Product Change Notice (PCN)

Ref no: 3009054

Concerning Part Name: PISN

Product Type: Power Inductor

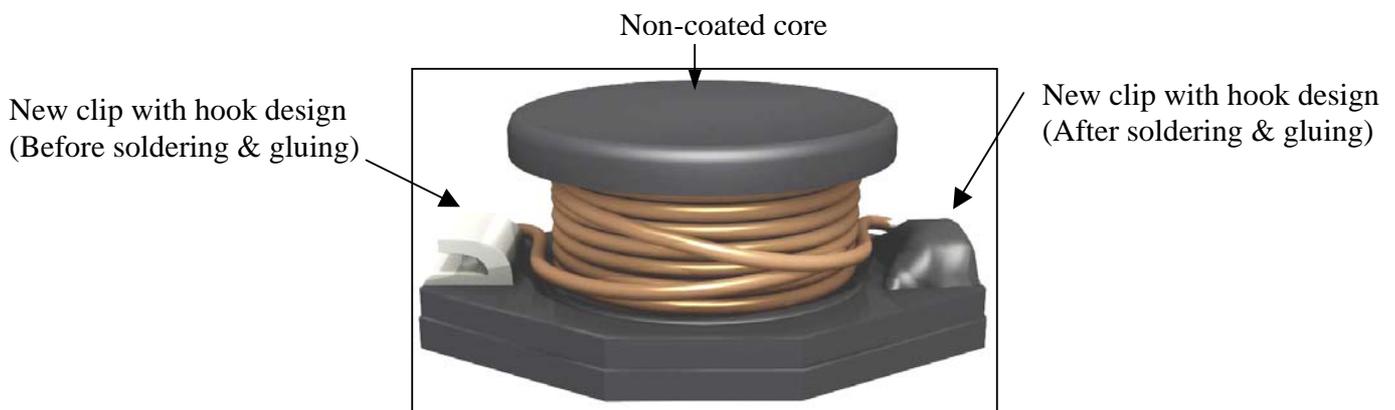
Transition Version --> new clip and base (refer to picture)

REASON for clip: To improve the wire termination robustness and to introduce lead free solder

REASON for base: To match the new clip design

Complete Version --> new ferrite core, non-coated (refer to picture)

REASON: To improve marking permanency and adhesive strength between core and base.

Expected Influence: All electrical parameters remain as per FASTRON specification, however sample testing for approval is recommended only for the complete version.
